ADDENDUM NO. 2 TO ITB # 17-0074-4

FOR: MEMORIAL STADIUM

**MEMORIAL STADIUM
ITB #17-0074-4**

ADDENDUM NO. 2

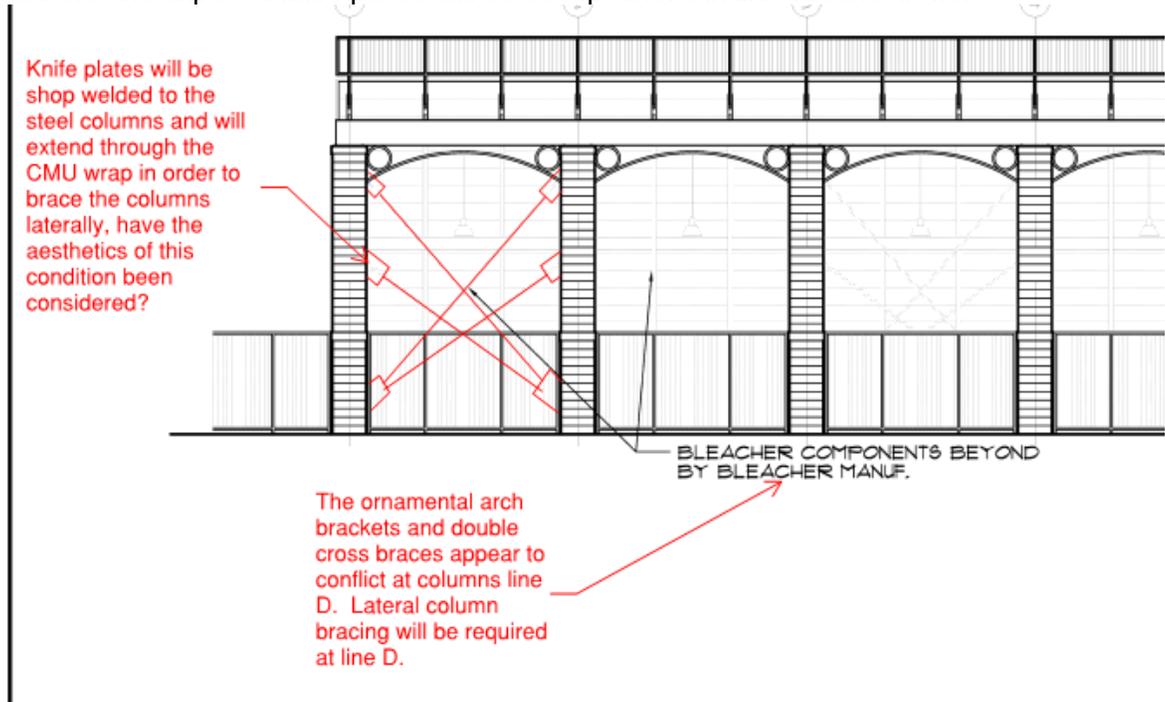
4. Request: We would like to submit the following light fixtures for prior approval on this project.

<u>Type</u>	<u>MFG</u>	<u>Part</u>
H	Flex Lighting Solutions	CL1S-A-20K-40-WIDE-CL-LV-STEM-10V-PROLV + CL1-120R + SAFETYCABLE
N1	NLS Lighting	CAL-1-TP1-S1-T3-32L-7-40K-UNV-AMBRZ + A18-L-WM-BRZ-CAL1
U1	Targetti USA	KPLM-ND-ZM-L2-40 + 1DU2525B + 1DU2521 + 1DU2530
U1	Targetti USA	KPL-ND-WW-L2-40 + 1DU2325BA + 1DU2394 + 1DU2530
U2	Targetti USA	KPL-ND-ZM-L2-40 + 1DU2325BA + 1DU2394 + 1DU2530

Answer: Approved

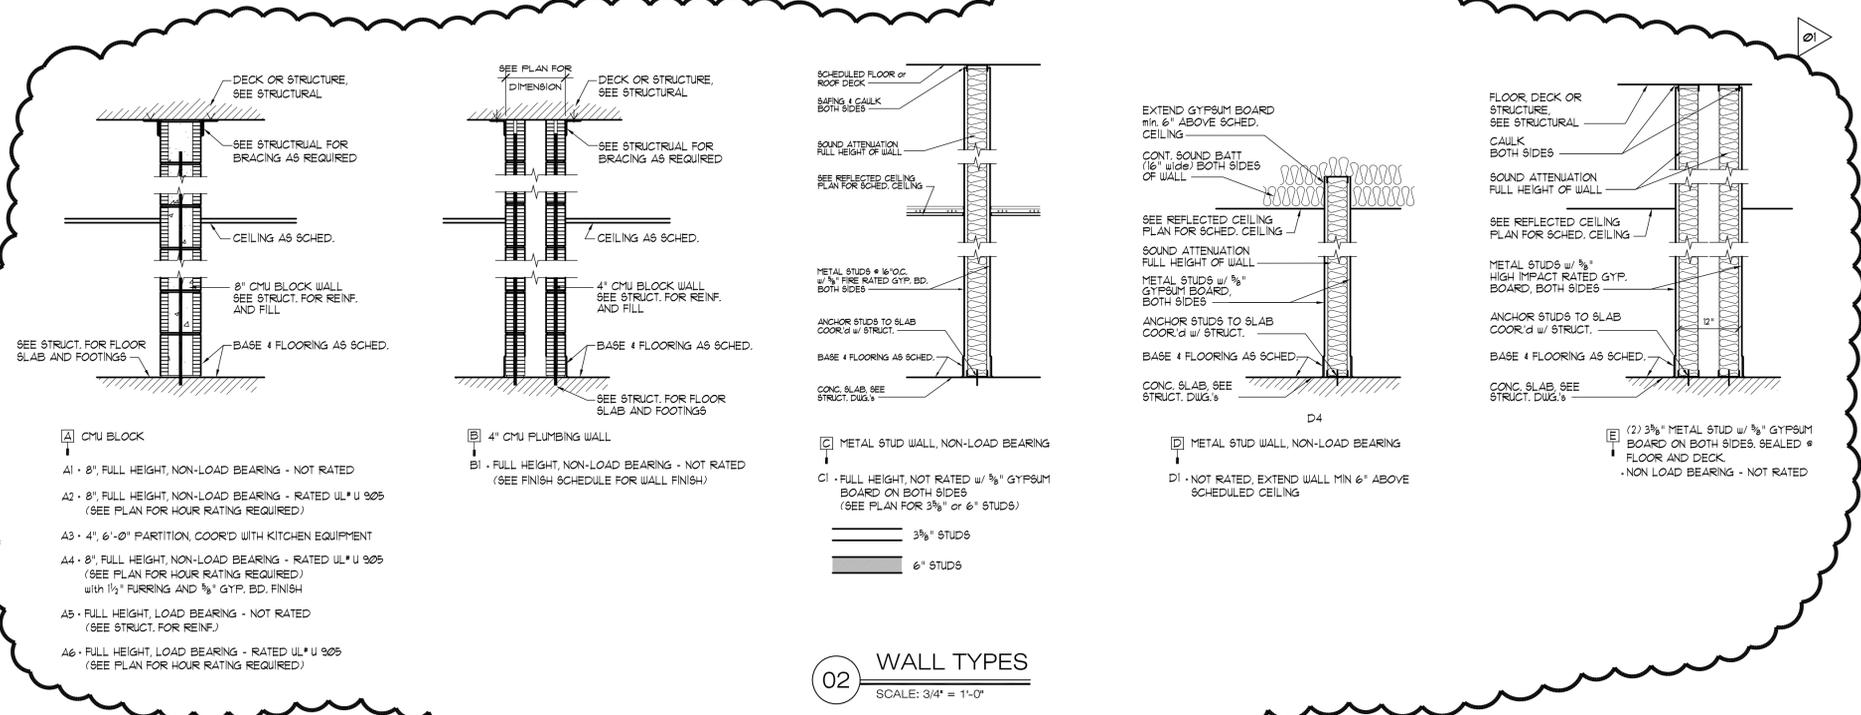
(B) Column line D will need to be braced laterally, and the double cross braces shown on A204 and A205 may interfere with the location of the arch brackets (this conflict could be avoided more easily if the brackets are added to the grandstand scope of work per the previous RFI). Further, the lateral bracing must be affixed directly to the grandstand support column using a knife plate which will extend through the CMU wrap. Please confirm that the project teams understands that lateral bracing is required at column row D and that the exposed knife plates will be acceptable. An illustration follows:

Answer: No issues with this structurally. See this as a major impact aesthetically. Whose package it will be under is not for the Design Team to decide.

Drawing No.:
LSP-101

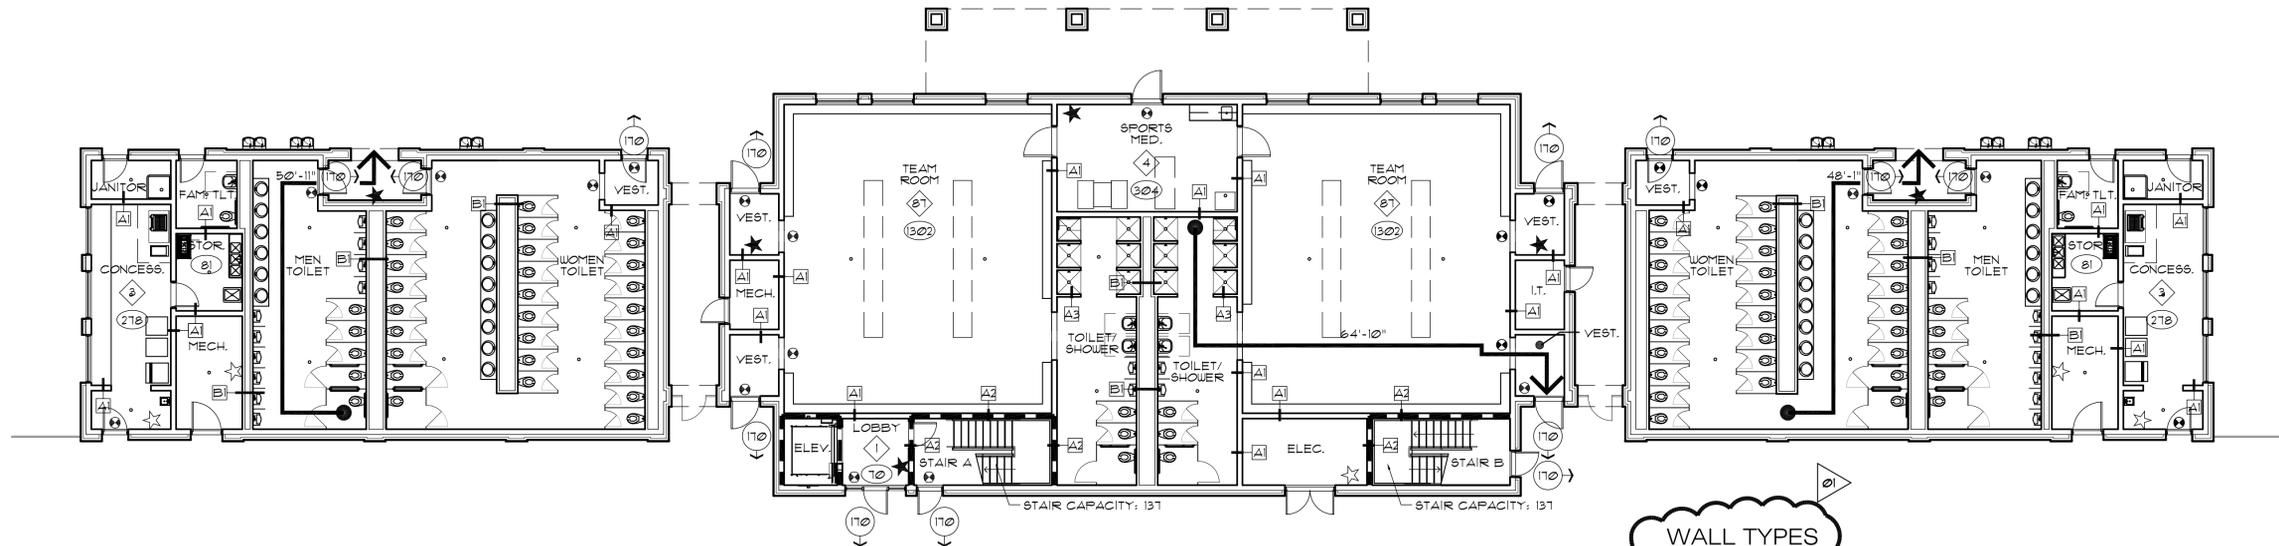
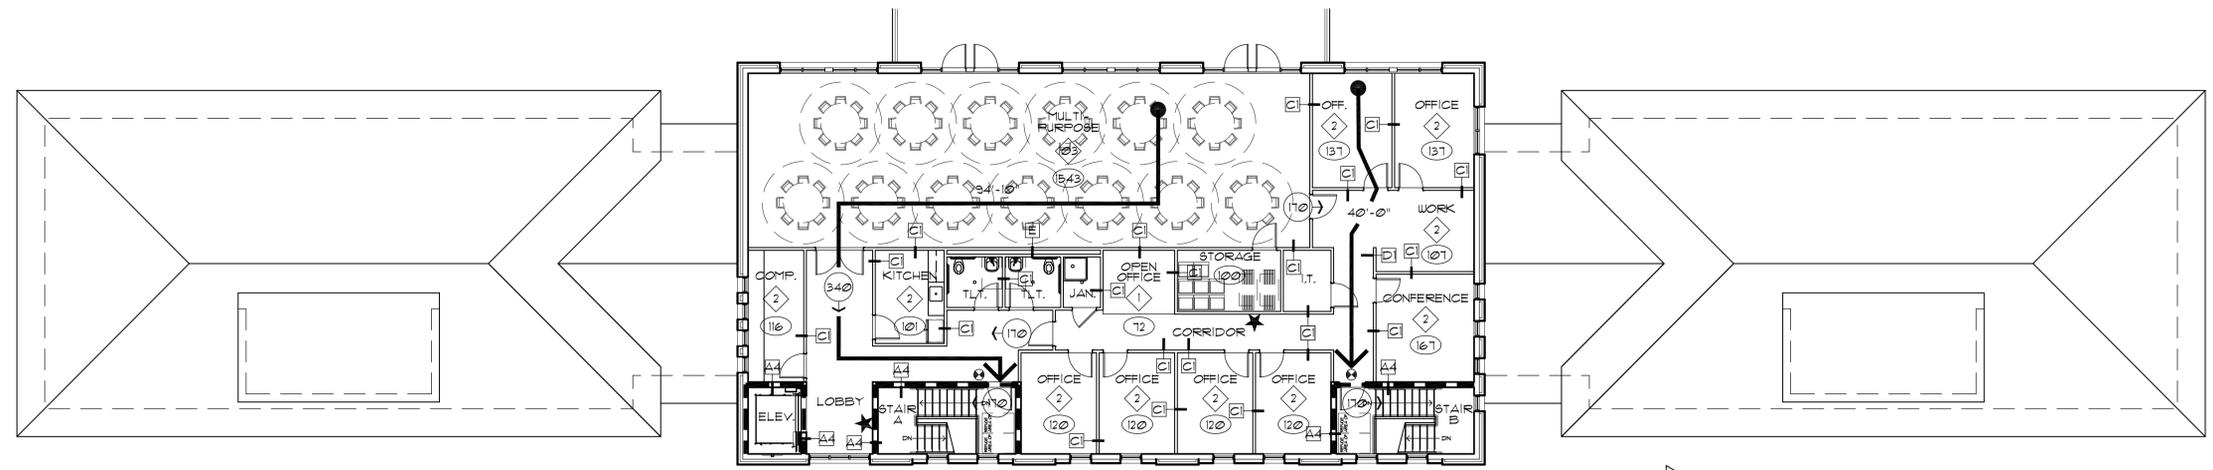
14. Question: In reference to wall construction: I could not find wall tags on the floor plan, nor a wall type plan itself. Will a "wall types" plan be provided and will wall tags be provided to correlate to the wall types? Size and gauge of material needed would be helpful as well.

Answer: Attached are revised LSP sheets (4 total) to address the question about wall types. The metal stud sizes are indicated, but the gauge will be provided by specialty engineering or the metal stud manufacturer to meet the requirements outlined in the structural documents.
